## NOTIFICATION

#0016

**SUBJECT:** Ballistic Parachute “Blowout” Skin Inspection and Installation

**MODELS AFFECTED:** All Sling 4 and Sling 4 TSi aircraft with parachutes installed / to be installed

## PARACHUTE BLOWOUT SKIN INSTALLATION

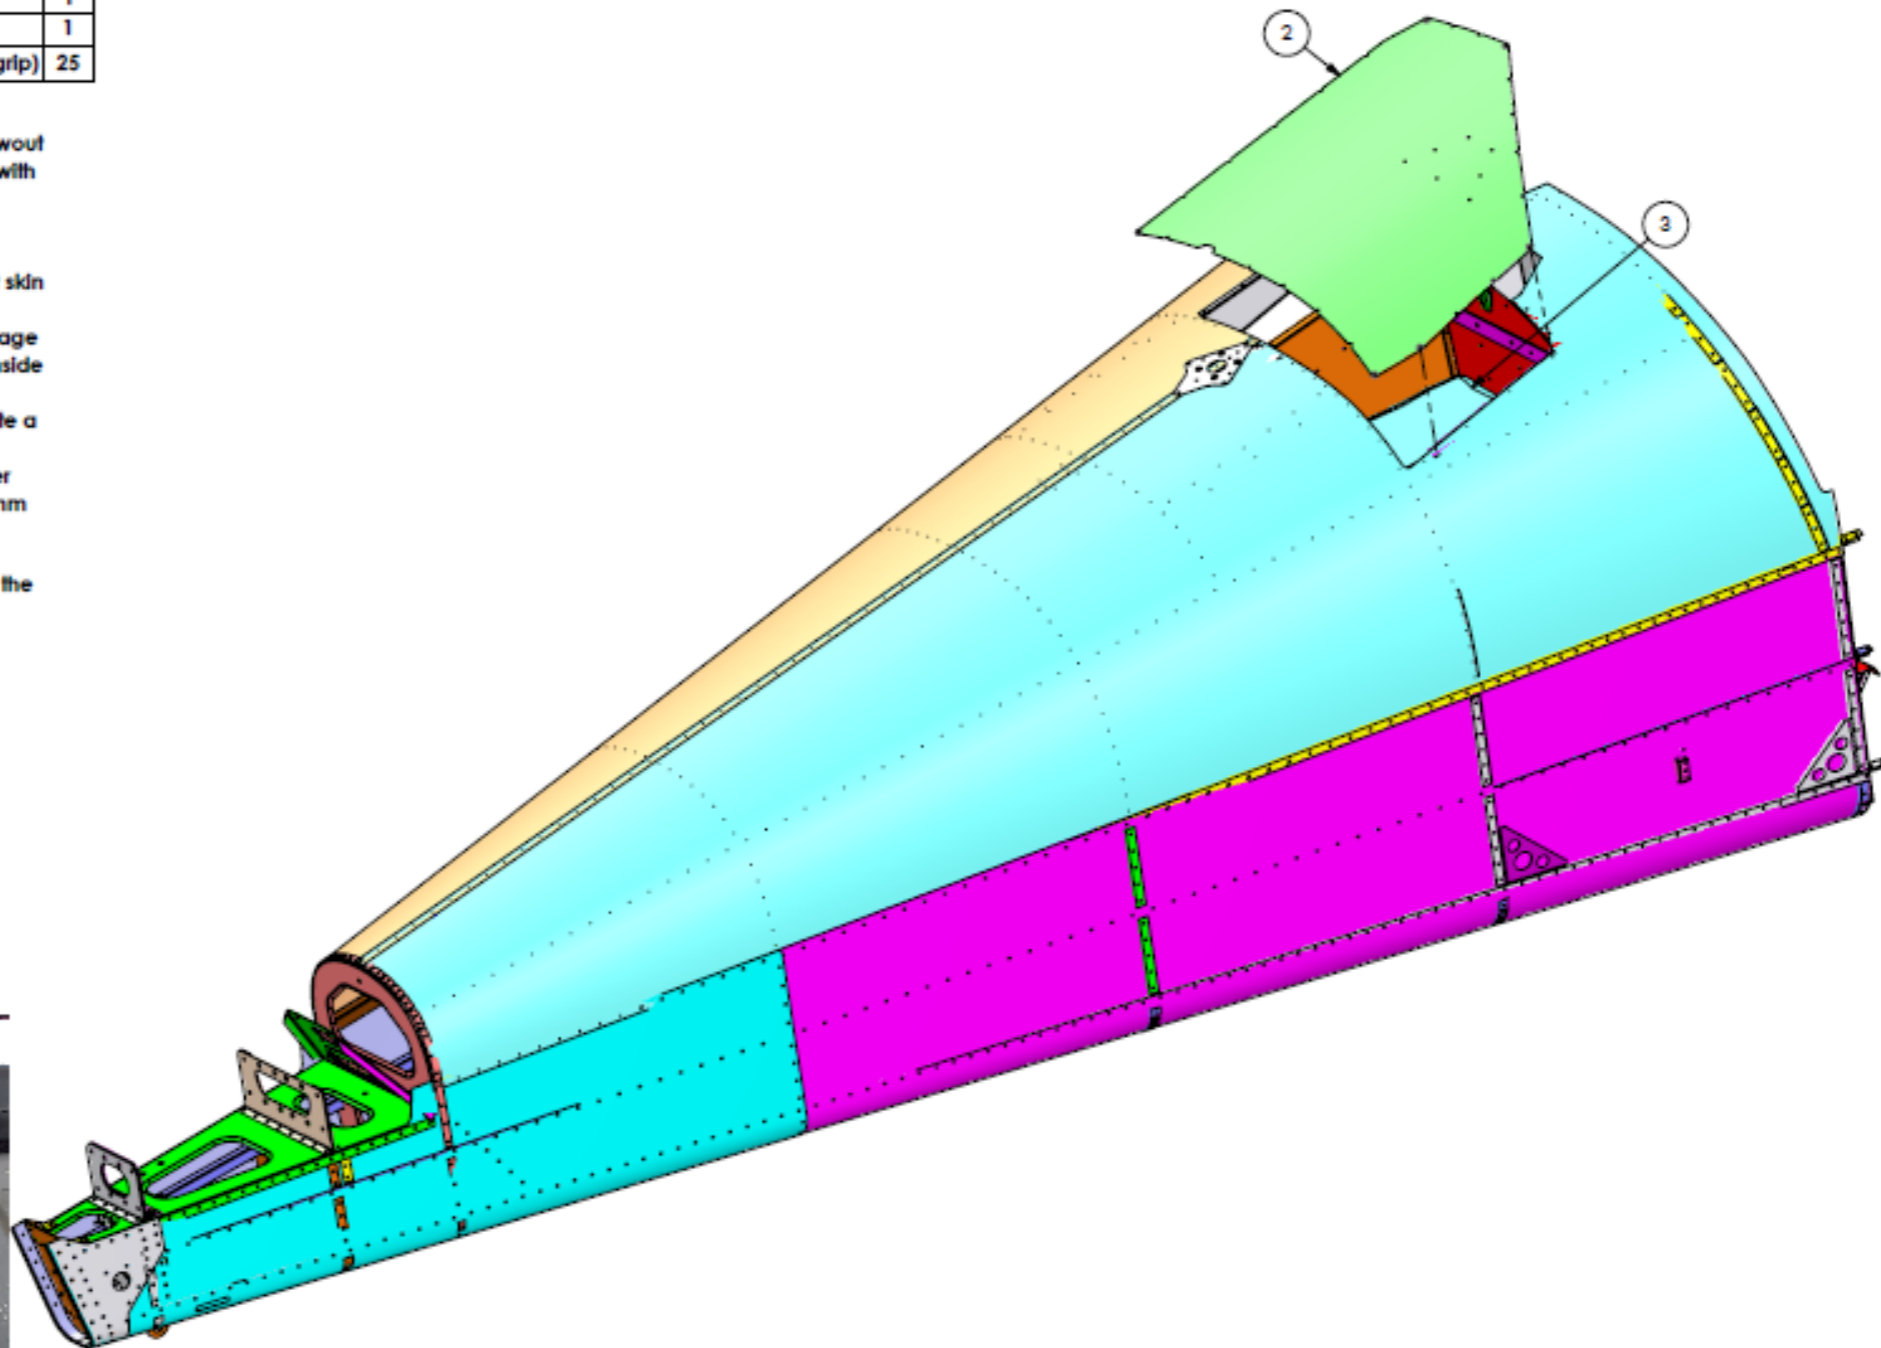
1. Align the Blowout skin with the Rear Fuselage and ensure that the Blowout skin covers the Parachute compartment and no cables are interfering with the skin.

2. Use masking tape to keep the Blowout skin in place.
3. Mark and drill 3.2mm holes into the Rear Fuselage.
4. Cleco the Blowout skin onto the Rear Fuselage and trace the Blowout skin onto the Rear Fuselage. Then remove the Blowout skin.

5. Apply PVA release agent onto the Blowout skin where the Rear Fuselage and Blowout skin will make contact. Apply PVA release agent on the inside of the traced area of the Rear Fuselage as well. Leave to dry.

6. Apply silicone inside of the traced area on the Rear Fuselage to create a gasket.
7. Install the Blowout skin by using a 0.4mm feeler gauge or shim spacer between the Rear Fuselage and the Blowout skin when riveting 3.2 x 8mm rivets. This will create a water tight seal and also removable when deploying the Parachute.

8. Refer to the Magnum Rocket guide No 02-rt for installation of arming the rocket. (ONLY CERTIFIED PERSONEL MAY ARM THE ROCKET)
